Office Action Summary

10/666,462

DETAILED ACTION

FIG. 4

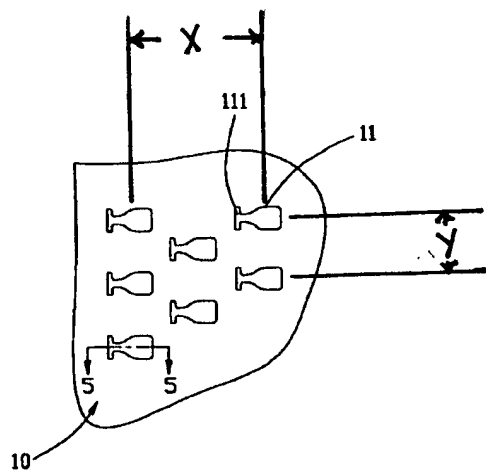
Lin discloses an apparatus comprising a printed circuit board (PCB) 5 having a plurality of contact pads 51; a connector 1 mounted on the PCB 5; and an integrated circuit (IC) package 6 for insertion into the connector 1, having a plurality of input/output (I/O) lands 61. Figure 4 shows the connector 1 with a plurality of contact opening 11 including a vertical pitch having a first uniform distance and a horizontal pitch having a second uniform distance. Figures 7 and 8 shown pitch distances of the I/O lands 61 of the IC package 6 and the contact pads 51 of the PCB 5 match with the contact opening 11 of the connector 1. Although Lin does not states the connector 1 being a zero insertion force (ZIP) connector, Figure 1 clearly shows that the connector 1 of Lin is a ZIP connector because the IC package 6 is simply dropped into the connector 1.
